$ert \mathcal{A}_{\mathbb{R}}$
	J. f.
	$+\epsilon$
	· Pr
	<u> </u>
	13 September 1961
	AW4
	AWA
	Re: Air-Fed Incinerator Model 1 Specification #354 - 25 May 1961
A 4. 7	
Gentleme	n:
This is	in further reference to the ten (10) Air Fed Incinera-
COLE B	ICRI I. DO COVERDA NY VANIN BENAVA AMANGRAAAGAA
	del 1, as covered by your above specification.
Enclosed	are nine (9) Drawings hW-h726h
Enclosed showing	the No. 25 Blower. We are submitting these drawings to
Enclosed showing you for	are nine (9) Drawings hW-h726h
Enclosed showing you for as shown	Drawings 4W-47264 the No. 25 Blower. We are submitting these drawings t your approval, as there are some changes over the blow on your Drawing 354-437. Please note that a 15-1/2" diameter cut wheel is
Enclosed showing you for as shown	prawings 4W-47264 the No. 25 Blower. We are submitting these drawings to your approval, as there are some changes over the blow on your Drawing 354-437. Please note that a 15-1/2" diameter cut wheel is noted on your Drawing 354-437. We have noted a

- SIZE 25 REVERSIBLE INDUSTRIAL EXHAUSTER, ARR. #4.	
	ROTATION: X CLOCKWISE COUNTER CLOCKWISE DISCHARGE: Bottom Horizontal	
	EACH COMPLETE WITH: 1-7-1/2 HP 3500 RPM

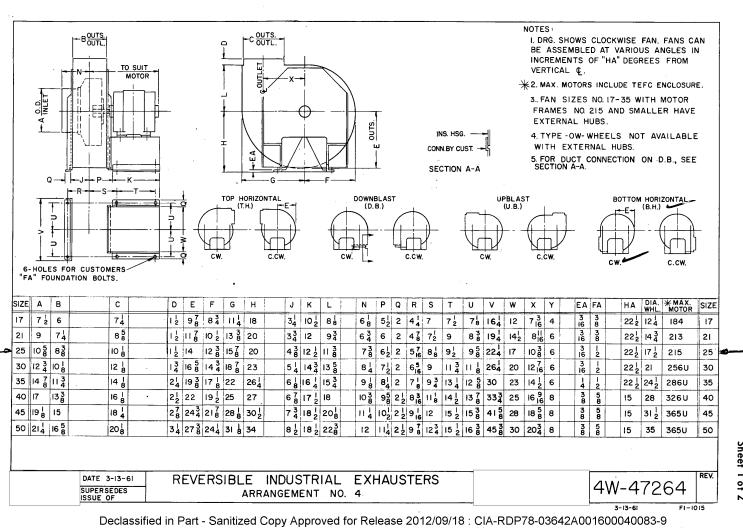
Enclosed showing you for as shown	the No. 25 Blower. We are submitting these drawings to your approval, as there are some changes over the blown on your Drawing 354-437. Please note that a 15-1/2" diameter cut wheel is noted on your Drawing 354-437. We have noted a 14-1/2" diameter cut wheel on drawing 4W-47264. advises that a 14-1/2* diameter no. C-6967, their No. 59K-12078. This is the proper size wheel for the required rating. A
Enclosed showing you for as shown	the No. 25 Blower. We are submitting these drawings to your approval, as there are some changes over the blown on your Drawing 354-437. Please note that a 15-1/2" diameter cut wheel is noted on your Drawing 354-437. We have noted a 14-1/2" diameter cut wheel on drawing 4W-47264. advises that a 14-1/2" diameter cut wheel to you on your Order No. C-6967, their No. 59K-12078. This is the proper size wheel for the required rating. A 15-1/2" diameter wheel would overload the motor.

Enclosed showing you for as shown	the No. 25 Blower. We are submitting these drawings to your approval, as there are some changes over the blown on your Drawing 354-437. Please note that a 15-1/2" diameter cut wheel is noted on your Drawing 354-437. We have noted a 14-1/2" diameter cut wheel on drawing 4W-47264. advises that a 14-1/2" diameter of the required rating. A 15-1/2" diameter wheel would overload the motor. Do you approve of the 14-1/2" diameter wheel?
Enclosed showing you for as shown	the No. 25 Blower. We are submitting these drawings to your approval, as there are some changes over the blown on your Drawing 354-437. Please note that a 15-1/2" diameter cut wheel is noted on your Drawing 354-437. We have noted a 14-1/2" diameter cut wheel on drawing 4W-47264. advises that a 14-1/2" diameter no. C-6967, their No. 59K-12078. This is the proper size wheel for the required rating. A 15-1/2" diameter wheel would overload the motor. Do you approve of the 14-1/2" diameter wheel? Dimension N-H on your Drawing 354-437 is 17".

Enclosed showing you for as shown	the No. 25 Blower. We are submitting these drawings to your approval, as there are some changes over the blown on your Drawing 354-437. Please note that a 15-1/2" diameter cut wheel is noted on your Drawing 354-437. We have noted a 14-1/2" diameter cut wheel on drawing 4W-4,7264. advises that a 14-1/2" diameter No. C-6967, their No. 59K-12078. This is the proper size wheel for the required rating. A 15-1/2" diameter wheel would overload the motor. Do you approve of the 14-1/2" diameter wheel? Dimension H-H on your Drawing 354-437 is 17". Dimension H on our Drawing 4W-47264 is 20", or an increase of 3" in the distance from the floor line to the centerline of the blower. This will raise the centerline of the blower 3"
Enclosed showing you for as shown	the No. 25 Blower. We are submitting these drawings to your approval, as there are some changes over the blown on your Drawing 354-437. Please note that a 15-1/2" diameter cut wheel is noted on your Drawing 354-437. We have noted a 14-1/2" diameter cut wheel on drawing 4W-47264. advises that a 14-1/2* diameter no. 59K-12078. This is the proper size wheel for the required rating. A 15-1/2" diameter wheel would overload the motor. Do you approve of the 14-1/2" diameter wheel? Dimension H-H on your Drawing 354-437 is 17". Dimension H-H on our Drawing 4W-47264 is 20", or an increase of 3" in the distance from the floor line to the centerline of the blower. This will raise the centerline of the blower 3" above the centerline of the Incinerator inlet duct.

Enclosed showing you for as shown 1.	the No. 25 Blower. We are submitting these drawings to your approval, as there are some changes over the blown on your Drawing 354-437. Please note that a 15-1/2" diameter cut wheel is noted on your Drawing 354-437. We have noted a 14-1/2" diameter cut wheel on drawing 4W-4,7264. advises that a 14-1/2" diameter No. C-6967, their No. 59K-12078. This is the proper size wheel for the required rating. A 15-1/2" diameter wheel would overload the motor. Do you approve of the 14-1/2" diameter wheel? Dimension H-H on your Drawing 354-437 is 17". Dimension H on our Drawing 4W-47264 is 20", or an increase of 3" in the distance from the floor line to the centerline of the blower. This will raise the centerline of the blower 3"
Enclosed showing you for as shown 1.	the No. 25 Blower. We are submitting these drawings to your approval, as there are some changes over the blown on your Drawing 354-437. Please note that a 15-1/2" diameter cut wheel is noted on your Drawing 354-437. We have noted a 14-1/2" diameter cut wheel on drawing 4W-47264. advises that a 14-1/2" diameter cut wheel on drawing 4W-47264. advises that a 14-1/2" diameter No. 59K-12078. This is the proper size wheel for the required rating. A 15-1/2" diameter wheel would overload the motor. Do you approve of the 14-1/2" diameter wheel? Dimension H-H on your Drawing 354-437 is 17". Dimension H on our Drawing 4W-47264 is 20", or an increase of 3" in the distance from the floor line to the centerline of the blower. This will raise the centerline of the blower 3" above the centerline of the Incinerator inlet duct. Is it possible to mount the Incinerator 3" above

] .		25X1
Attention:			· .	25 X 1
Subject :		erator, Model I, Spe d 25 May 1961	cification	
lentlemen:	man di wasan sawa	e nav		
We are	in receipt of	your letter of 13 S	eptember 1961 res	erding
the above s you are adv	subject. In revised that a 15	sponse to the questic inch diameter wheel	ons posed in your L is required. V	letter,
this drawin	We believe that ng you will not	rawing No. 4W-47264; the correct drawing to that the 3 inch did 2 does not occur.	is No. 4W-40132.	
e and 3 for drawings referenced tions for din submitting any determine the contractor of any determine the contractor of	the purpose of equired for the in the contracthe Model II in ling a proposal. This in connect under the presented that	contemplate a visit f transmitting to you make reservation is connection in connection	u (1) the addition, (2) the special drawings and special ou may also be in available for distinct of the Model of the model of the minimum si	tooling ifica- iterested scussion I
